January 4, 2010

Mr. Reid Rosnick  
Radiation Protection Division (6608J)  
U.S. Environmental Protection Agency  
1200 Pennsylvania Ave., NW  
Washington, DC 20460  
Via email: [Rosnick.Reid@epamail.epa.gov](mailto:Rosnick.Reid@epamail.epa.gov)

## Attachment

### Public Issues, Concerns, Recommendations from June 30, 2009 EPA Meeting in Canon City, Colorado

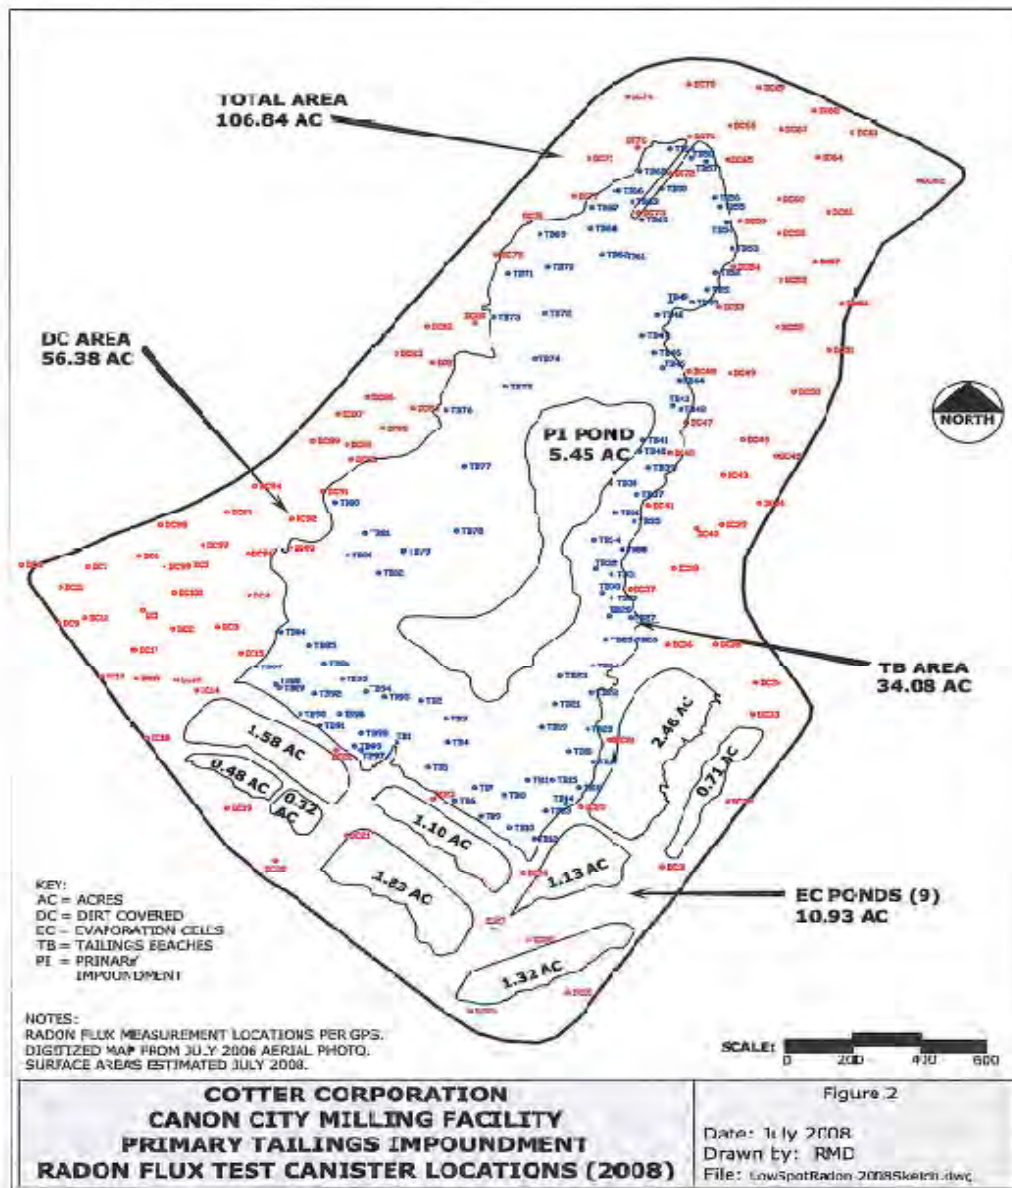
- i. **Case in Point:** Cotter Mill Primary Impoundment based upon 2008 data:
    1. 107 acres total, **NOT 40 acres**
    2. 56 acres dirt covered
    3. 34 acres exposed, **NOT 10 acres**

☒ 107 acres total

☒ 56 dirt covered

☒ 34 exposed

☒ 17 water covered

## MILDOS Risk Assessment Soil Samples and Results

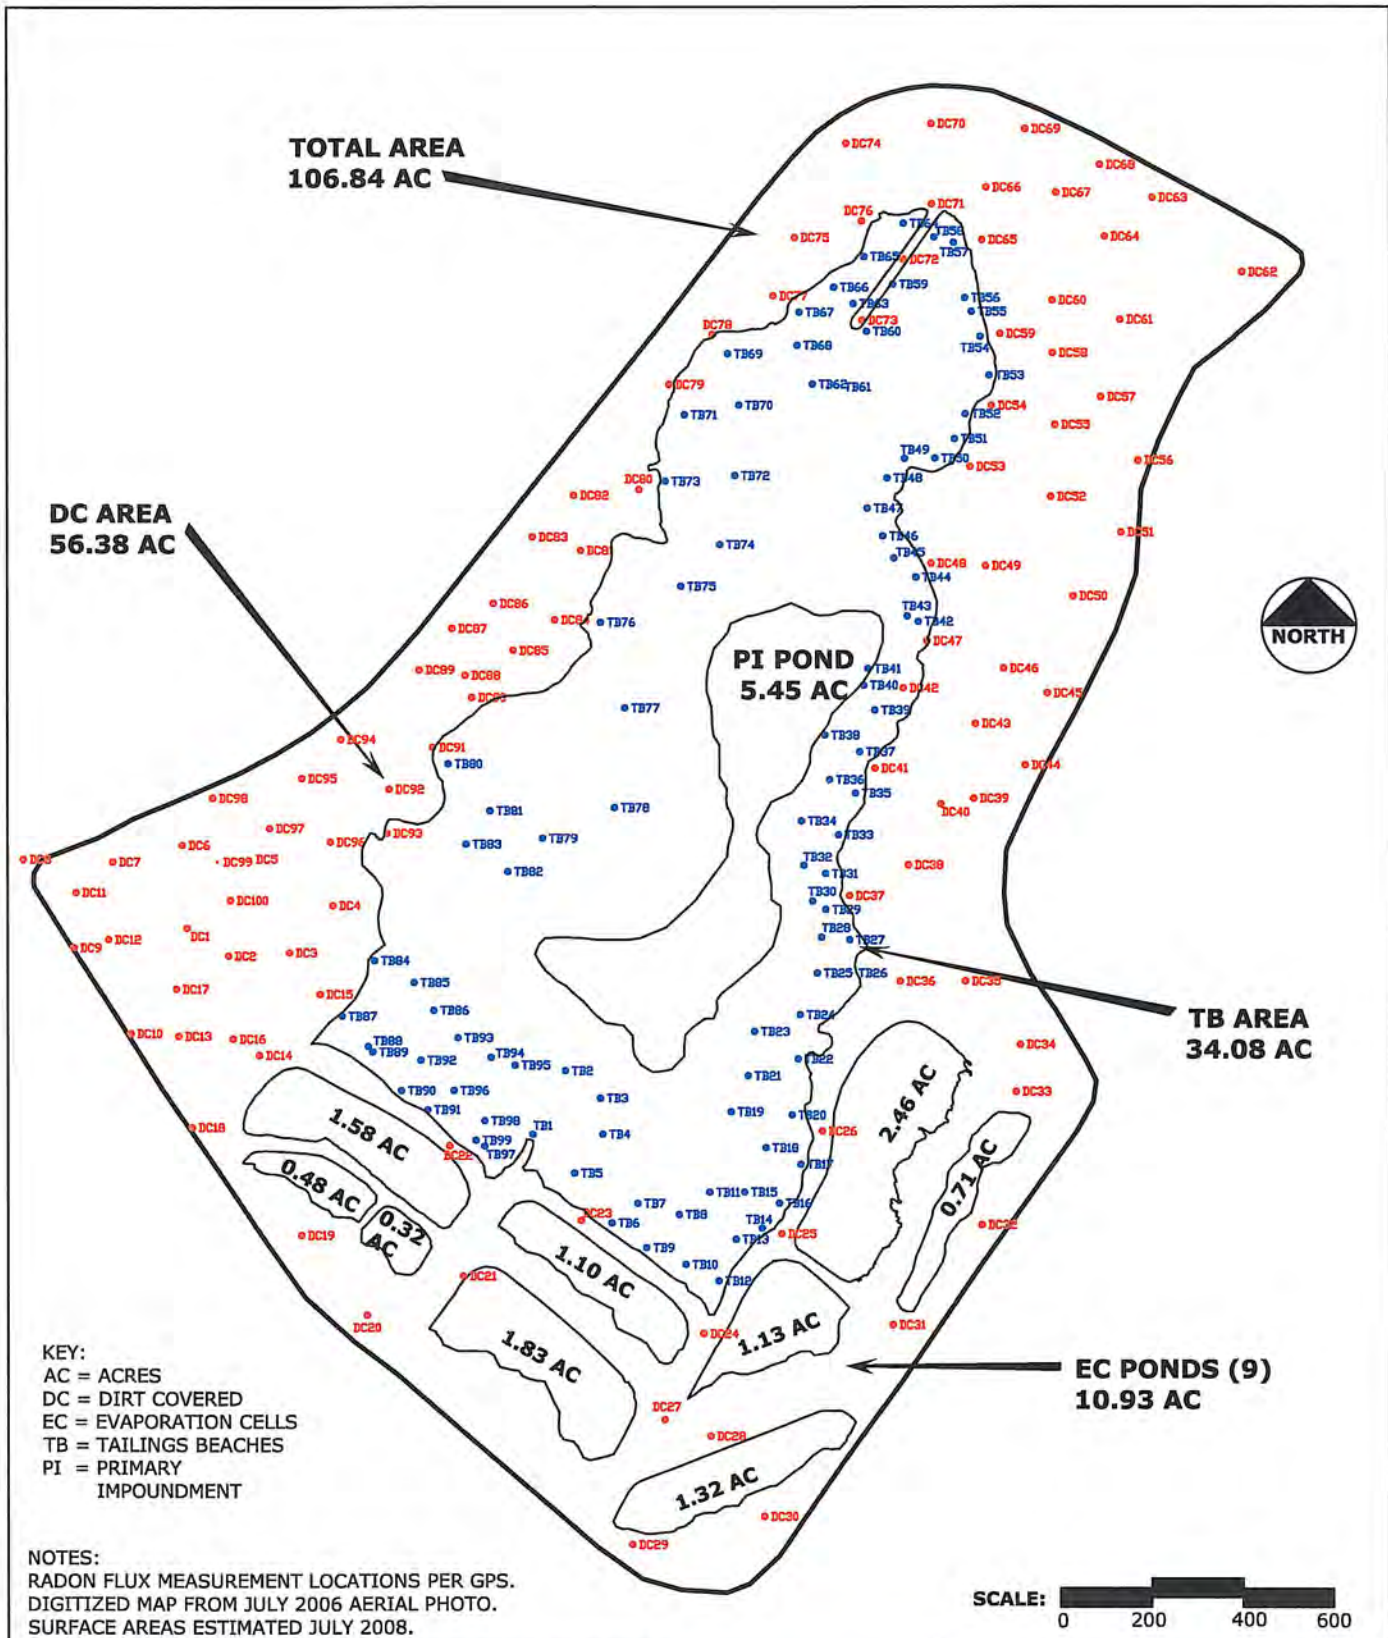
- a. While the Cotter Mill is not an ISL facility, they too have evaporation ponds that can vary significantly in water coverage throughout a year and contribute to radon flux. Soil samples MRA1 and MRA2 taken from Cotter's Evaporation Cell #8 in 2002 show high concentrations of Alpha emitting material (see **Reference – 4**). The test procedures and collection requirements requested by EPA in the May 5, 2009, letter are certainly more thorough than any annual testing performed at the Cotter Mill. An average of two charcoal canisters per each of Cotter's evaporation ponds over a 24-hour period once a year certainly is not as representative of radon flux emissions as the requested procedure would be, nor does it measure radon at 1, 2 or 3 meters above the pond (see **Reference – 5**). Results of this sort of radon testing would answer many radon questions from citizens living near a tailings impoundment with evaporation ponds.
